Access Compliance Report

Public Rights-of-Way

(Curb Ramps)

Intersection ID: 46196	Main Street: FERNSPRAY_RD	Cross Street: LUSTRE_RD	Location:	SE
ADA ID: 3232EA819F57	Ramp Type: PerpDiag	Initial Pass/Fail: Fail	Overall Compliance: No	Severity Score: 10
Codes/Mitigation Info/Possible Solution		Field Measurements/Component Compliance

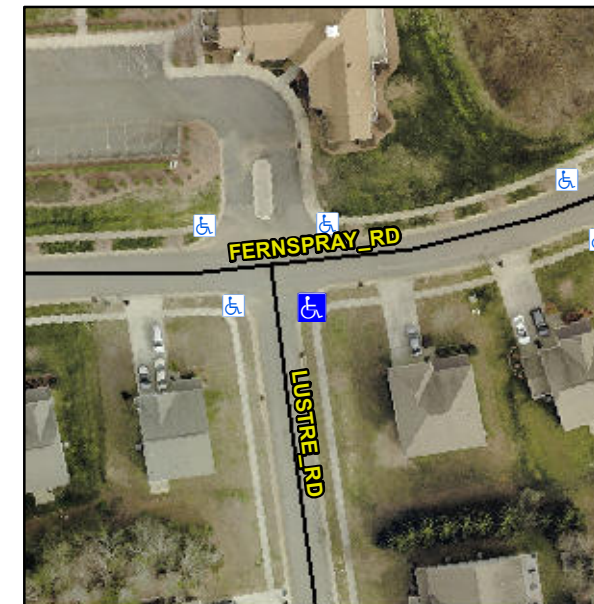
Not Found, R304.5.1, R304.5.3

Compliance	Description	Data	Compliance	Description	Data
N/A	Ramp Length (in)	70.0	Yes	Ramp Slope (%)	7.1
No	Ramp Width (in)	47.5	No	Ramp XSlope (%)	3.8
N/A	Flare Type LT	N/A	N/A	Flare Type RT	N/A
N/A	Flare Slope LT (%)	N/A	N/A	Flare Slope RT (%)	N/A
N/A	Flare Traversable LT?	N/A	N/A	Flare Traversable RT?	N/A
N/A	Landing Length (in)	N/A	N/A	DWS Provided?	N/A
N/A	Landing Width (in)	N/A	N/A	DWS Contrast?	N/A
N/A	Landing Slope (%)	N/A	N/A	DWS Length (in)	N/A
N/A	Landing X Slope (%)	N/A	N/A	DWS Full Width?	N/A
N/A	Landing Curb? (Y/N)	N/A	N/A	DWS Offset (in)	N/A
N/A	Shared Landing?	N/A			
N/A	Gutter Ponding?	N/A	N/A	Gutter Slope (%)	N/A
N/A	Gutter Lip Ht (in)	1.0	N/A	Gutter X Slope (%)	N/A
N/A	Painted X Walk1?	No	N/A	Painted X Walk2?	No
	X Walk 1 Direction	To W		X Walk 2 Direction	To N
N/A	X Walk 1 Width (in)	N/A	N/A	X Walk 2 Width (in)	N/A
	X Walk 1 Slope (%)	1.8		X Walk 2 Slope (%)	5.7
	X Walk 1 X Slope (%)	2.4		X Walk 2 X Slope (%)	0.6

Remove & Replace Curb Ramp With Two New Directional Ramps or Equivalent.
